Subject: Installing Cross Arm Window Lifters

Figure 5

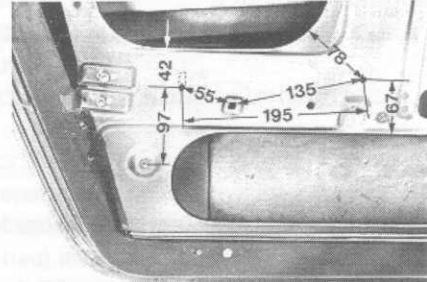
The new window lifters also have an additional guide which is bolted to the door (arrows in figure 4). To install these window lifter guides you must drill 2 7mm (9/32) holes using the coordinates listed in figure 5.

There were several versions of the cross arm style window lifters, and through the years they have been superseded several times to the final part numbers listed in this catalog. These numbers have different coordinates for drilling the 2 holes in the doors. The new coordinates are:

Coordinate shown in figure 5	New Coordinate
195	215
135	155
67	72
78	92

Prior to any drilling please verify the coordinates against the window lifter that you are installing.
